**Work Order ID 88926**

DESIGN #	DRAWN BY CP	<b>DART AEROSPACE LTD</b> HAWKESBURY, ONTARIO, CANADA	
CHECKED #	APPROVED #	DRAWING NO. <b>D3183</b>	REV. C SHEET 1 OF 4
DATE <b>04.02.17</b>		TITLE <b>BRACKET ASSEMBLY</b>	SCALE 1:1
A	03.01.24	NEW ISSUE	
B	03.06.17	REMOVE BEARING; 1.012 WS 0.882	
C	04.02.17	ADD -045/-9; 0.182 WAS 0.431	
C1	04.11.09	0.830 WAS 0.850

DRAWING NO. D3183	TITLE BRACKET ASSEMBLY	REV.C1	DART AEROSPACE LTD ENGINEERING ORDER		D.E.O. NO. D3183-C1-1	SHEET NO. SHEET 1 OF 1	SCALE NTS
DRAWN <i>q</i>	CHECKED <i>L</i>	MFG. APPR. <i>M</i>	APPROVED <i>MP</i>	DE APPR. <i>MP</i>			
DATE 10.05.14	DATE 10.06.30	DATE 10.06.30	DATE 10/06/30	DATE 10/06/30

**D3183-5 BEARING:**  
**SPECIFICATION CONTROL DRAWING**

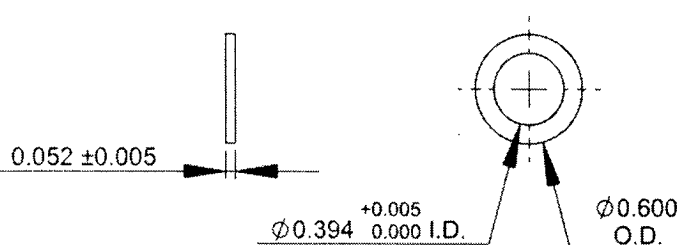
D3183-5 BEARING

ADD POSSIBLE SUPPLIER: KML P/N 6800-ZZ

BASIC LOAD RATING REQUIREMENT:      Cr = 1720 N (386 lb) MIN [DYNAMIC]  
Cor = 840 N (188 lb) MIN [STATIC]
